From: Lester, Robert <Robert.Lester@camden.gov.uk>
Sent: 24 May 2017 16:58
To: Jenny Bye
Subject: FW: Chester Court, Lissenden Gardens, 2017/1353/INVALID

From: Jenny Bye
Sent: 30 May 2017 15:36
To: Lester, Robert
Subject: Chester Court, Lissenden Gardens, 2017/1353/P
Attachments: 234861 Proposed site plan and elevations draft rev.pdf; Chester Ct GRP information.pdf

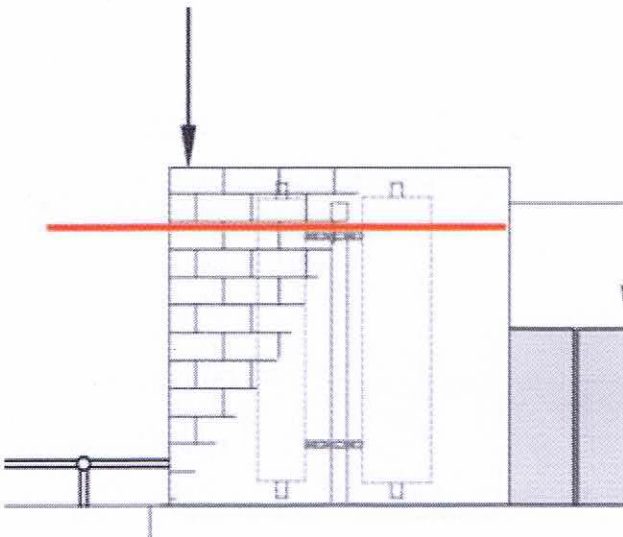
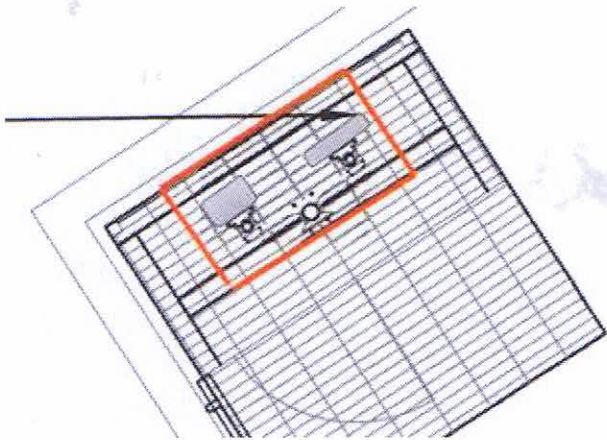
Following on from my earlier email. The conservation officer has asked why the enclosures can not be reduced in size as shown below (and also repositioned away from the edges of the roof) and disguised better as chimneys which would be a suitable structure for this building.

I have discussed this with the conservation officer and we are still concerned about the position of the antenna enclosures at the edge of the roof, and the scale of the enclosures.

If the antennas can not be reduced in height and scale and moved away from the edge of the roof further, then I will therefore need to issue a refusal on this application.

Thanks for your phone call on Thursday. I have now had an opportunity to speak with our designer. He has confirmed the GRP enclosures can be reduced as per the red lines on the first attachment. This is as small as the enclosures can be. The short sides cannot be reduced any further as the internal steel support framework would clip the antenna signal. The long rear side cannot be reduced any further due the steel support framework for the enclosure (which is different to the antenna steelwork). The designers have confirmed fake chimney pots can be added to the top of the enclosures if desired. The adjacent building to the north has pots on its chimneys, but it appears to be more a Victorian construction where chimney pots were commonplace, whereas the application site is a more modern building, as are the adjoining buildings to the south. It's not clear that chimney pots are going to add any authenticity to the appearance of the enclosures; I think they will make the structures more conspicuous. However, as this is something your conservation officer has raised, our designer has confirmed we can include pots with the reduced size GRP if this is still of interest.
